### CITY OF FAIR OAKS RANCH, TEXAS

AGENDA TOPIC: Consideration and possible action on a Concept Plan request from the applicant Urbanist Inc. on behalf of the property owners Brenda Minahan and Mark Minahan for a proposed multi-unit residential community on approximately 19.8 acres zoned Mixed Use Village District (MU) generally located north-east of the intersection of Dietz Elkhorn Road Ralph Fair Road

DEPARTMENT: Public Works and Engineering Services

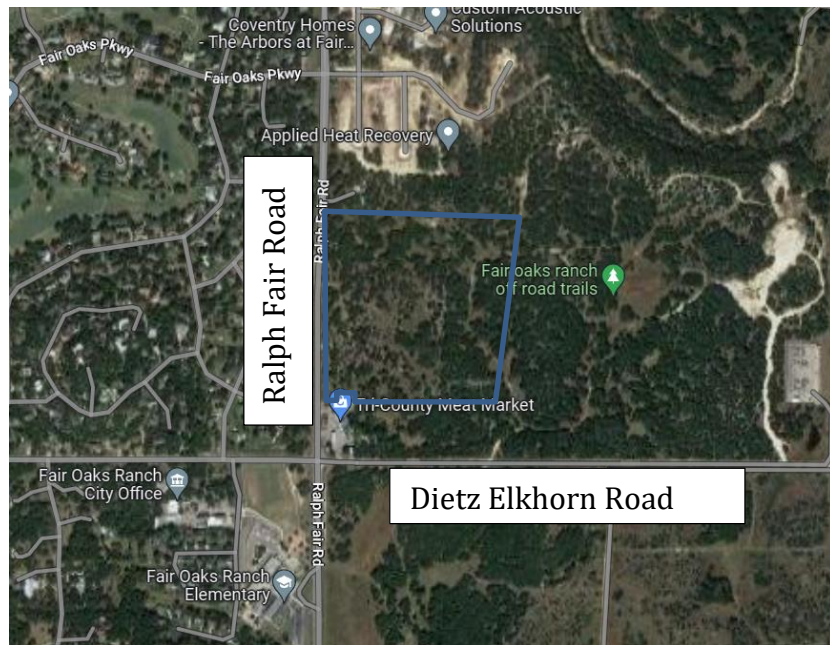
- City's roadway infrastructure may not be suitable and adequate for the proposed development. Further study with a Traffic Impact Analysis (TIA) is needed.
